REPLACEMENT OVERHEAD SIGN ASSEMBLY
I-40WB, 1/2 Mile in Advance of Exit #193B-A

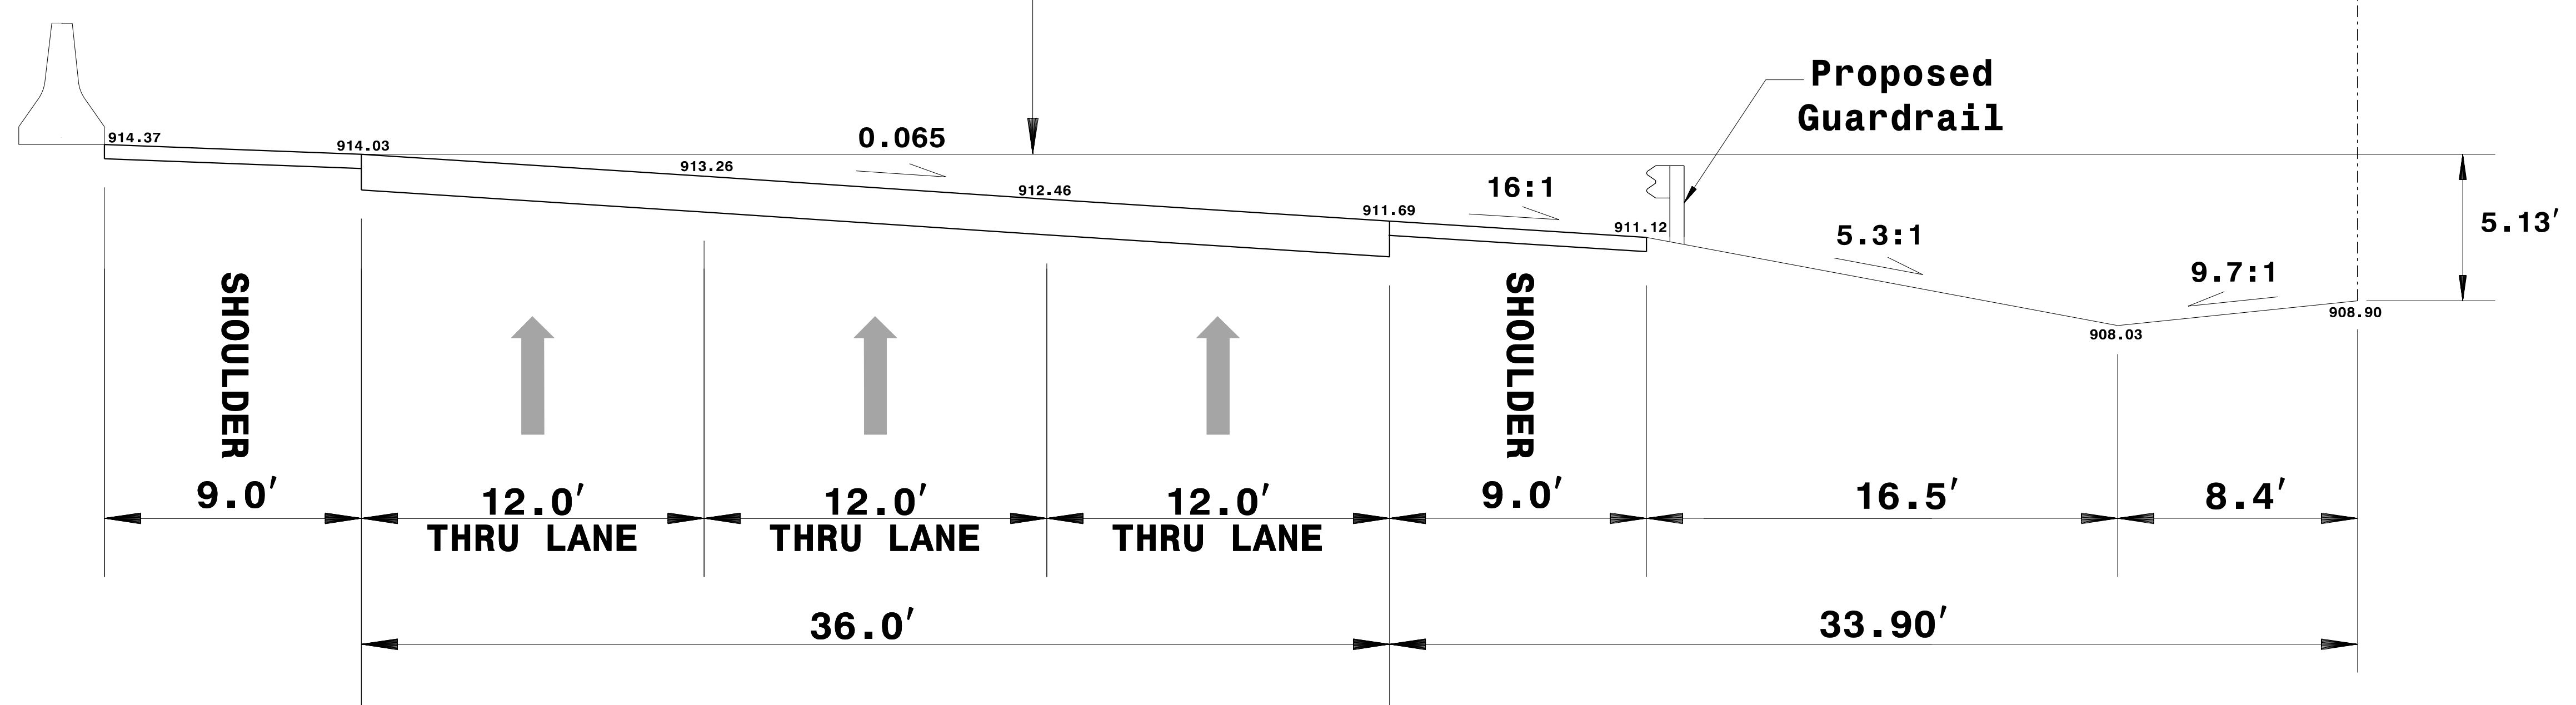
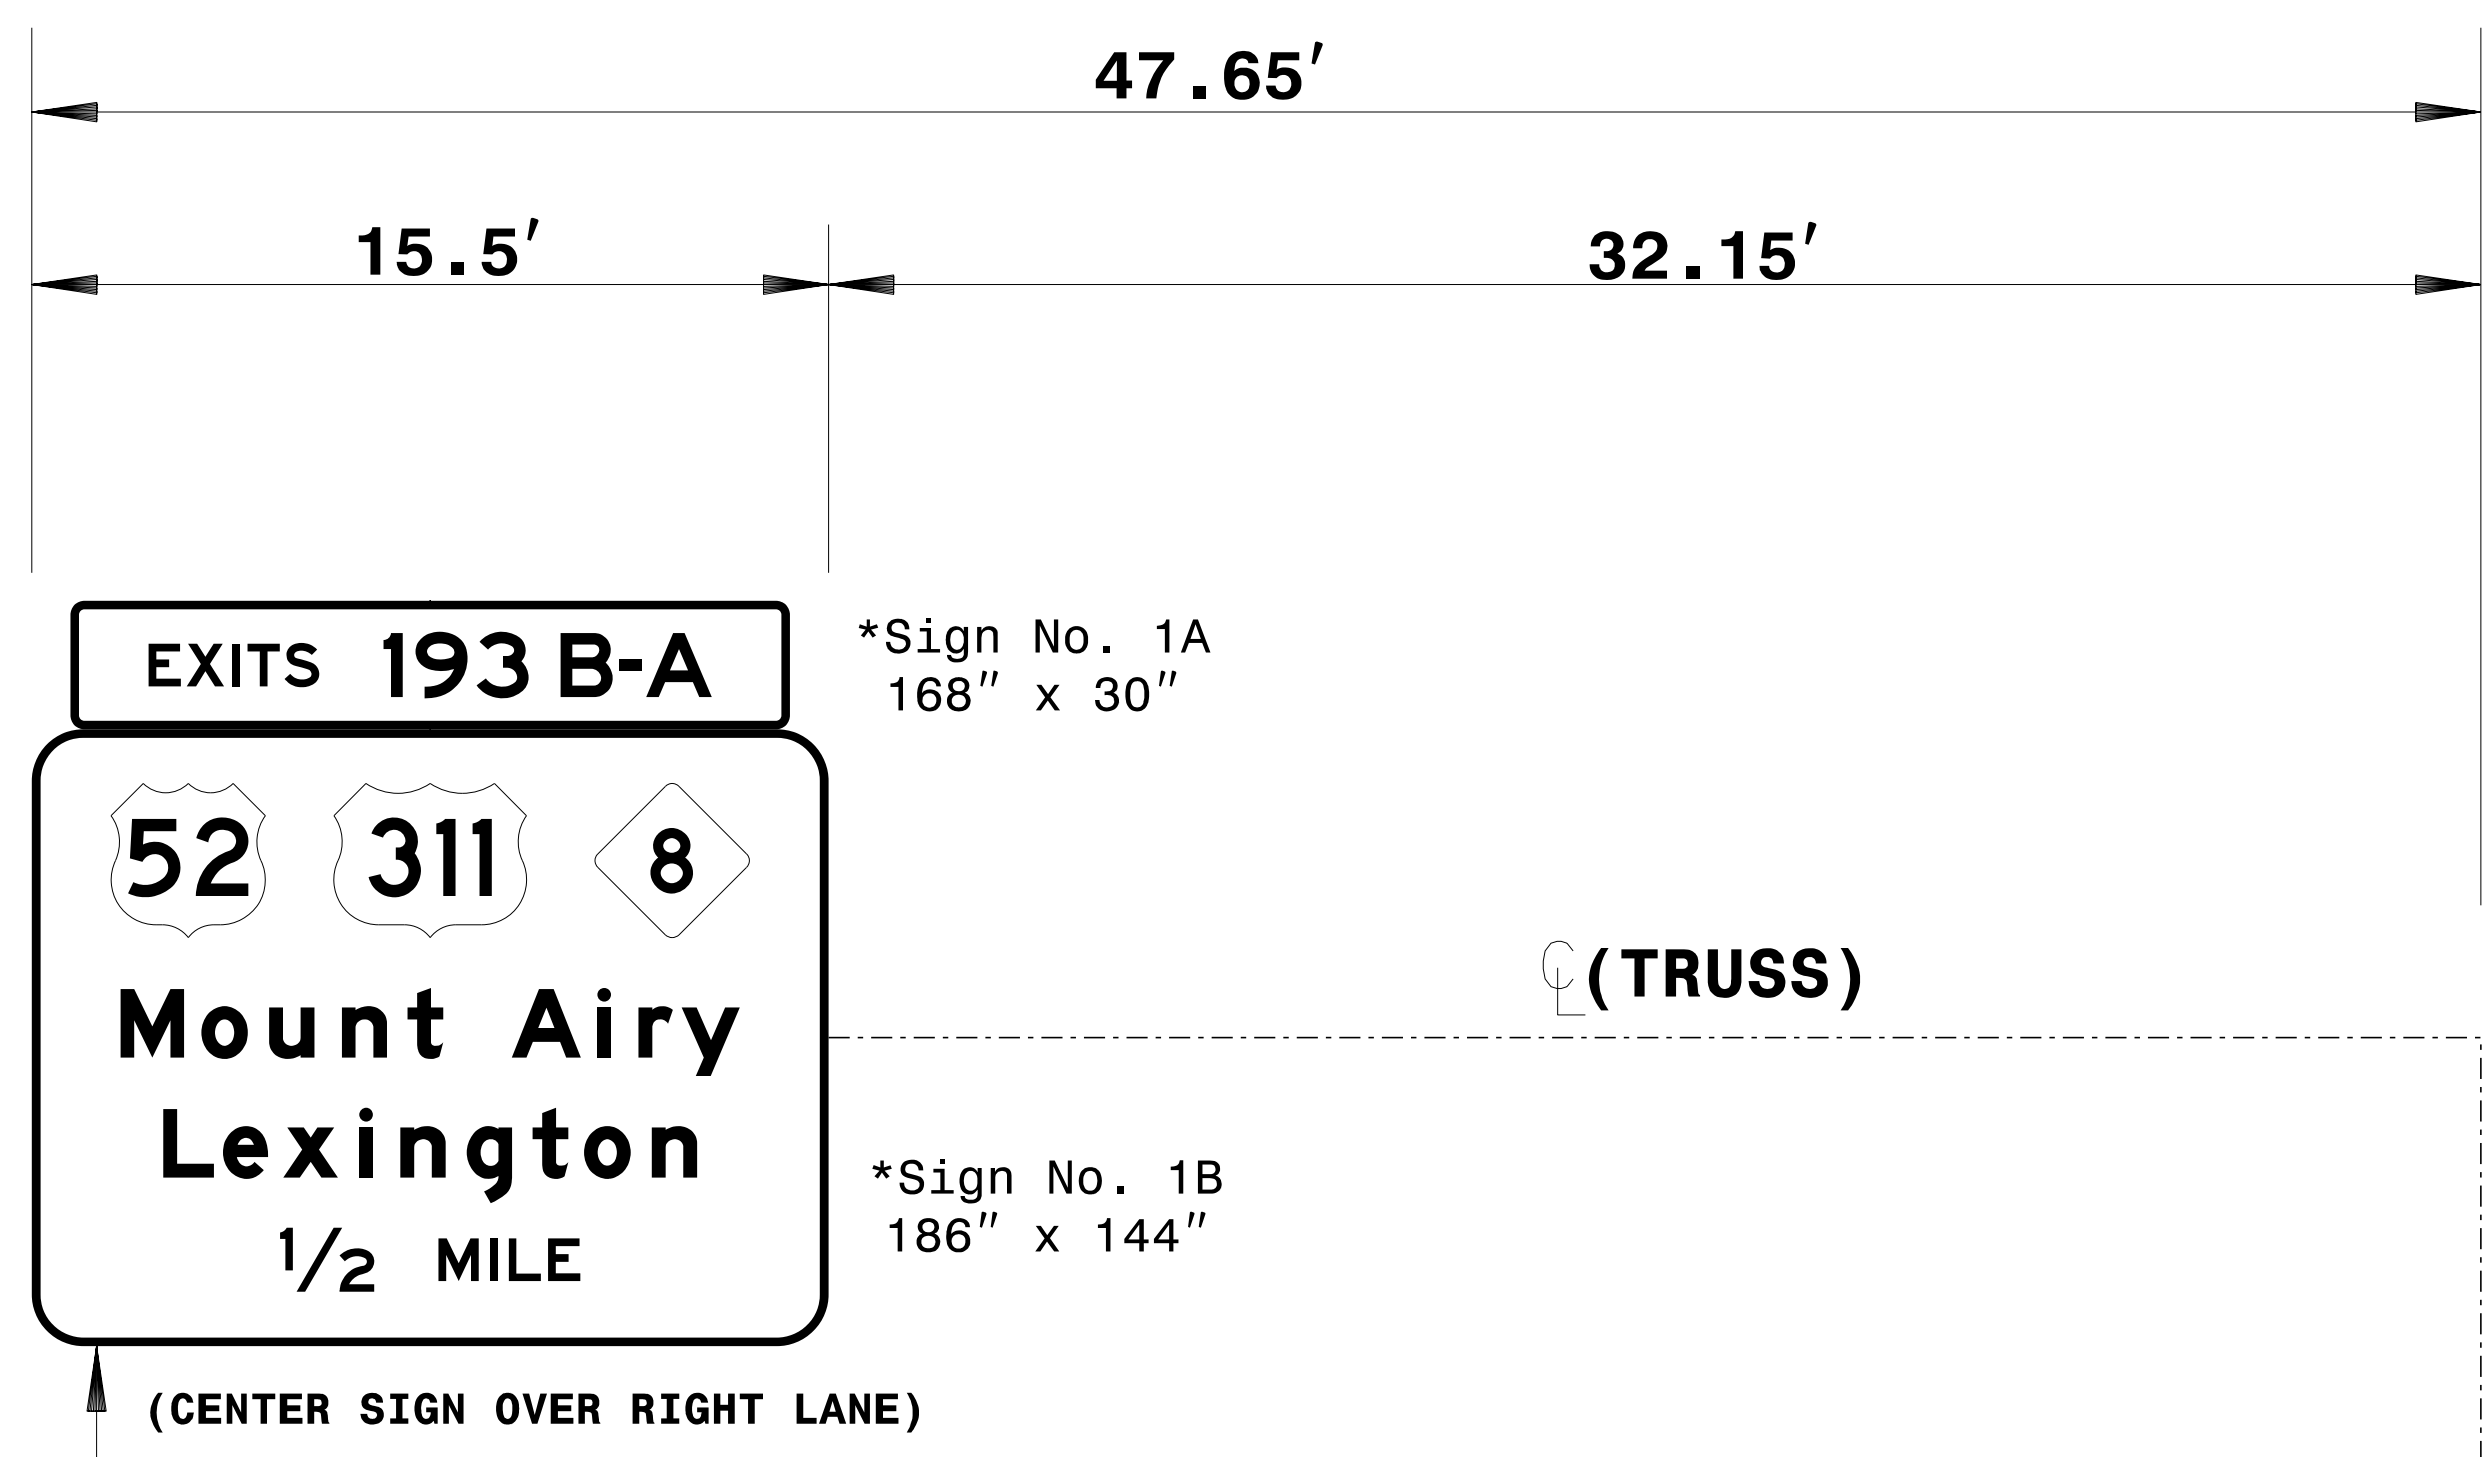
03/15 -
Revised location of proposed guardrail to be adjacent to the paved shoulder (per Roadway Design recommendaton).
